City and County of San Francisco
Department of City Planning

Environmental Impact Report

333 Bush Street

Final

FIGURE 19a:
View of Trinity Street from Bush Street

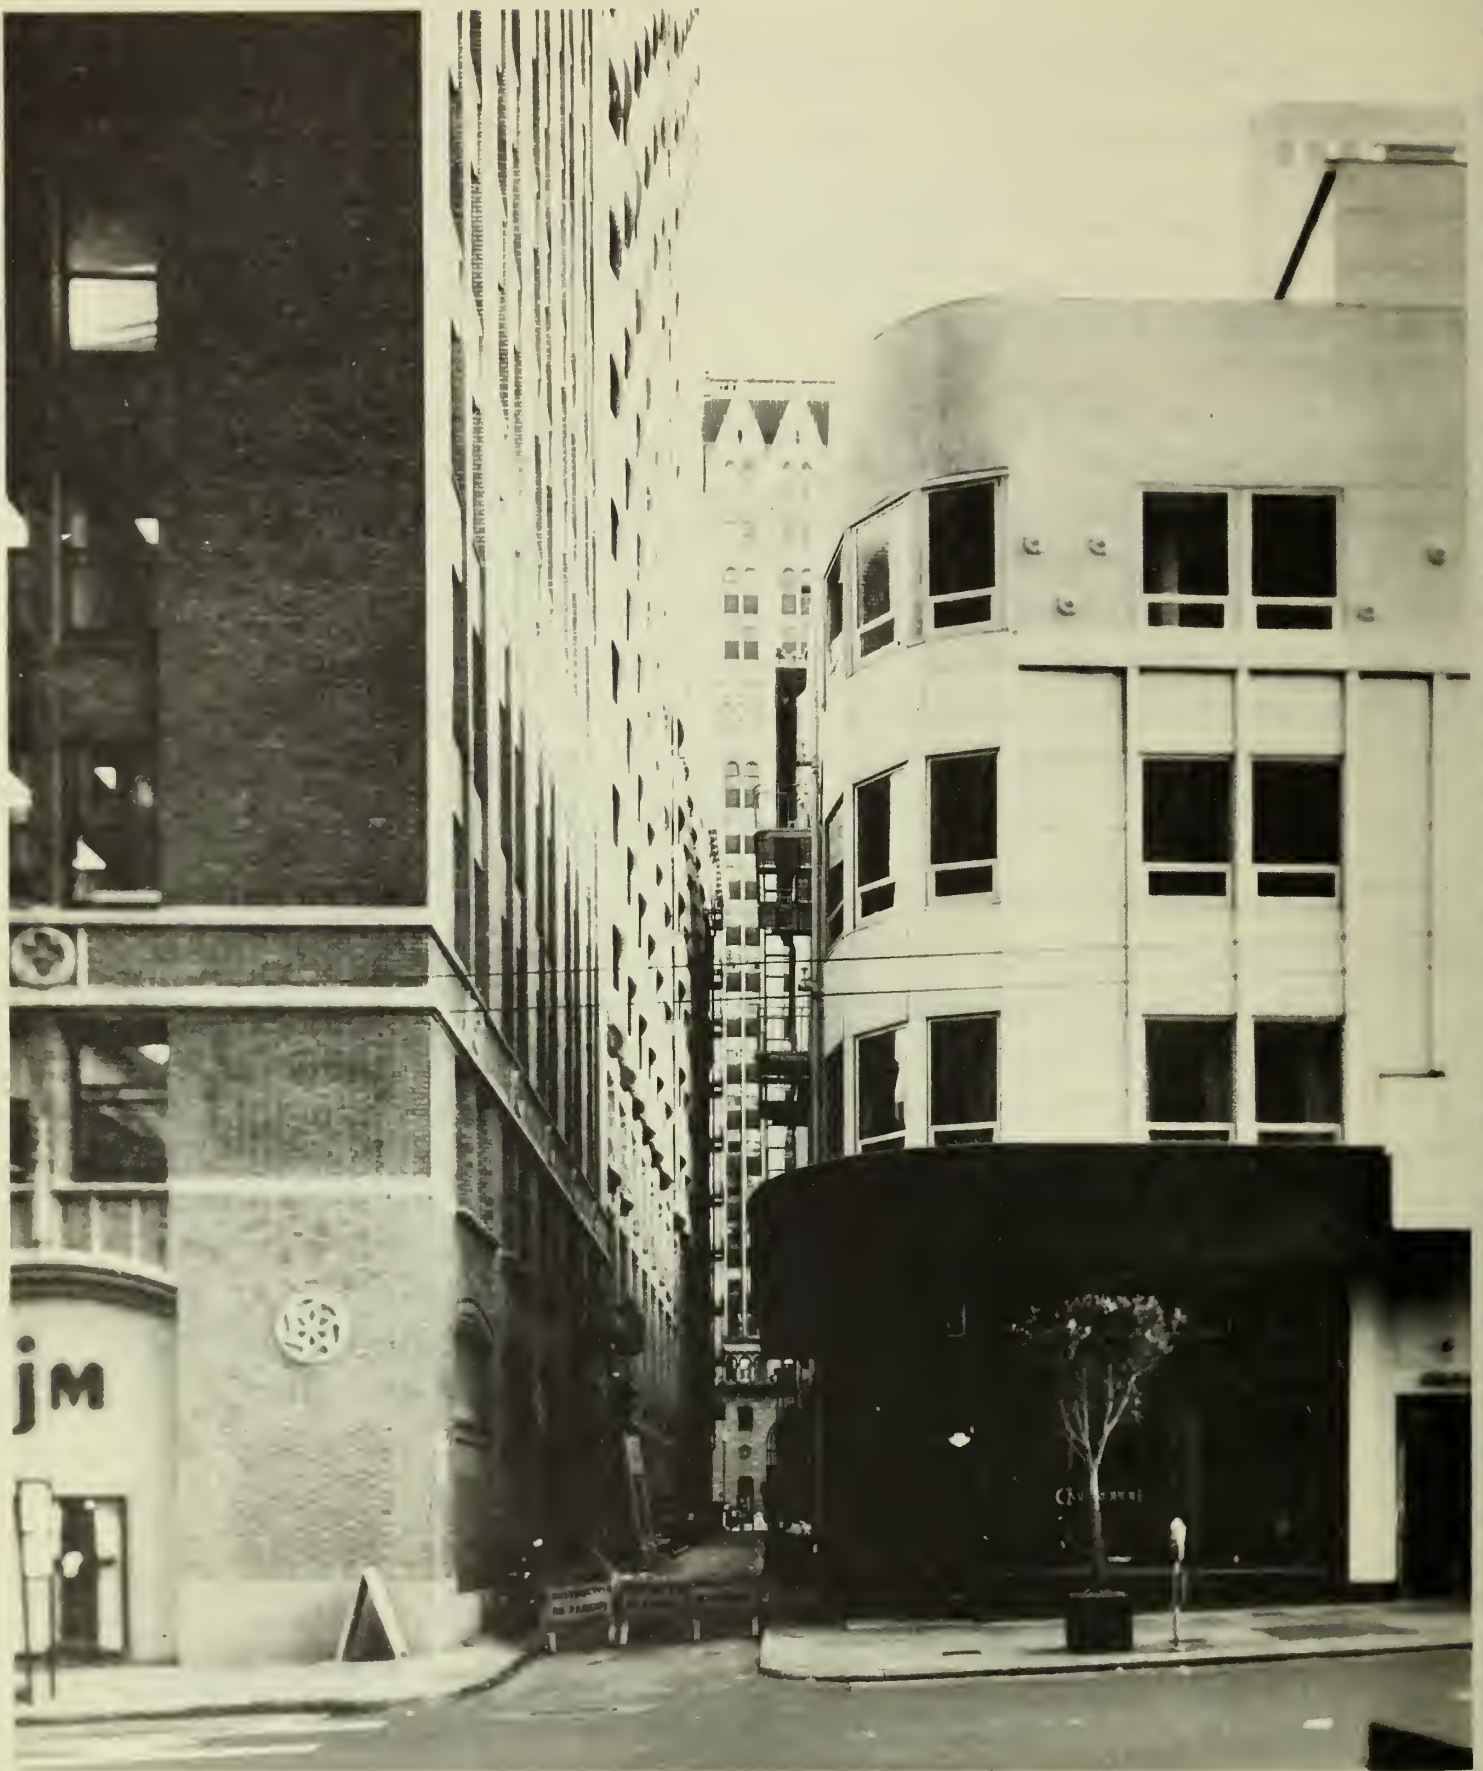
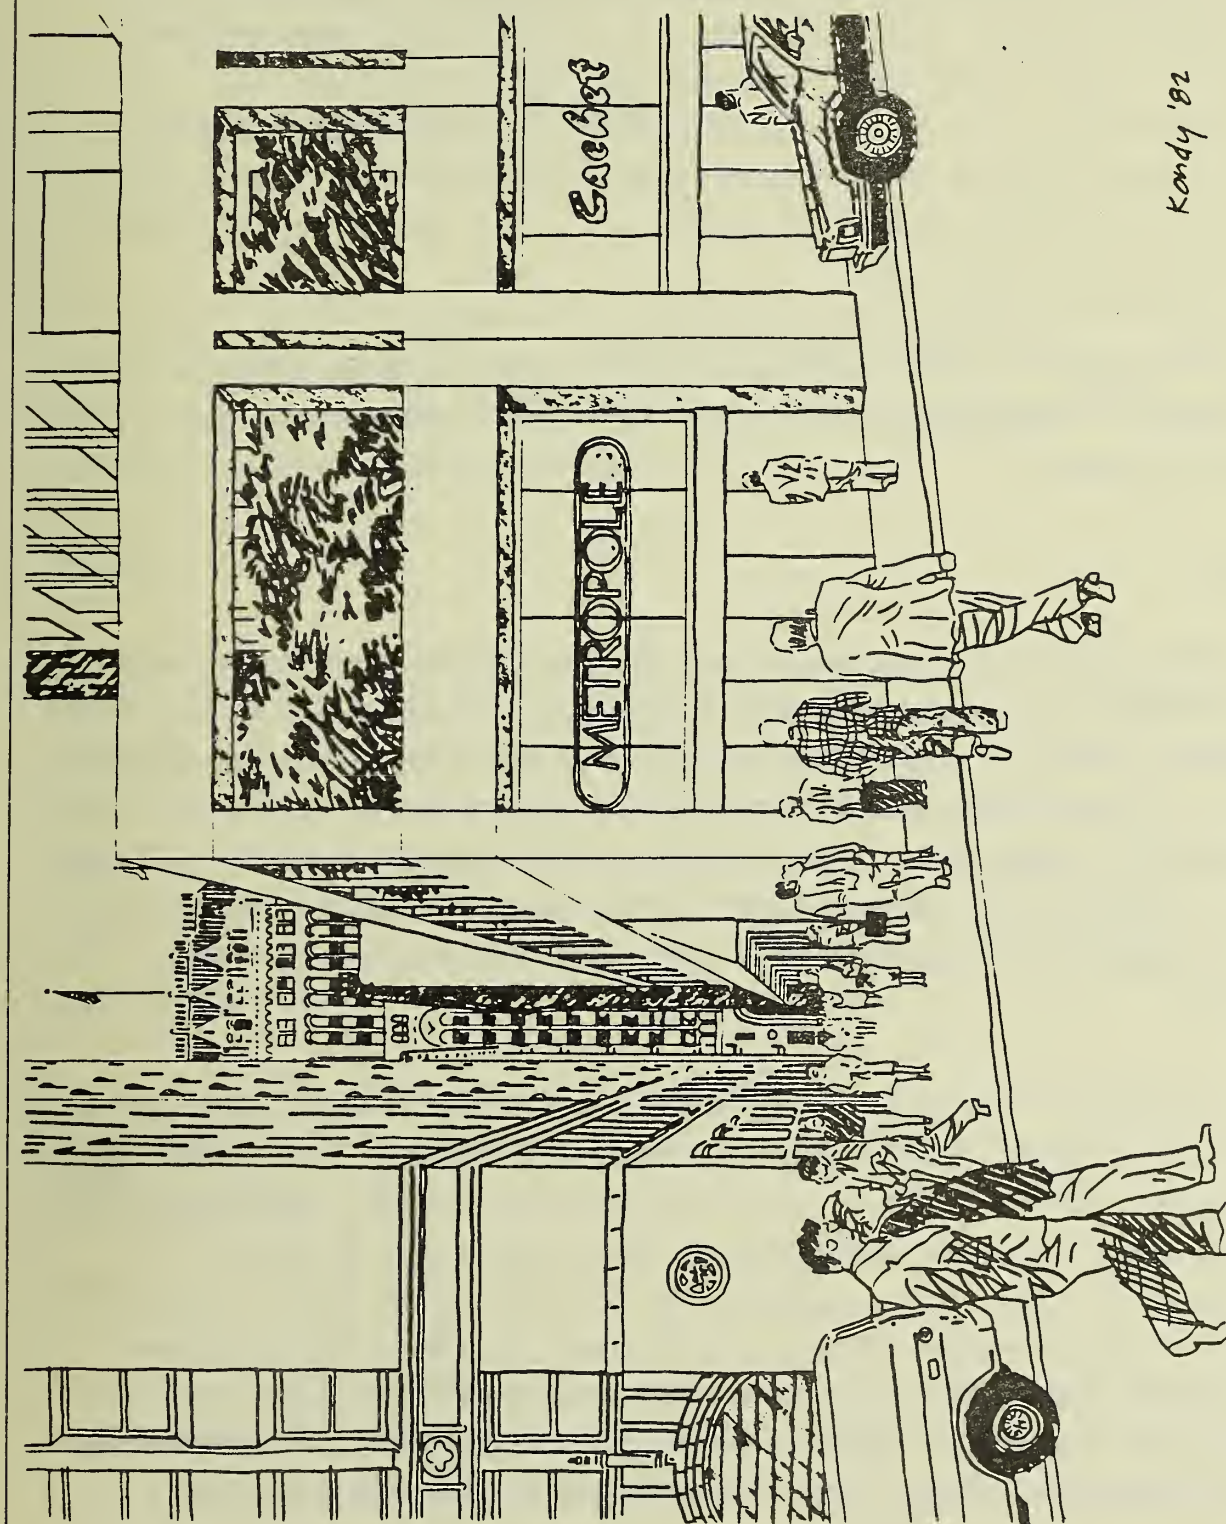
Sue Hestor: "P. 62 - the only reason this project may be compatible is because of other recently approved projects. It certainly doesn't fit in with other older more traditional low-intensity uses to the west of Montgomery Street."

A photograph looking southward on Trinity St. has been added as Figure 19a, p. 73a. A rendering of the same view with the proposed project has been included as Figure 19b, p. 73b.
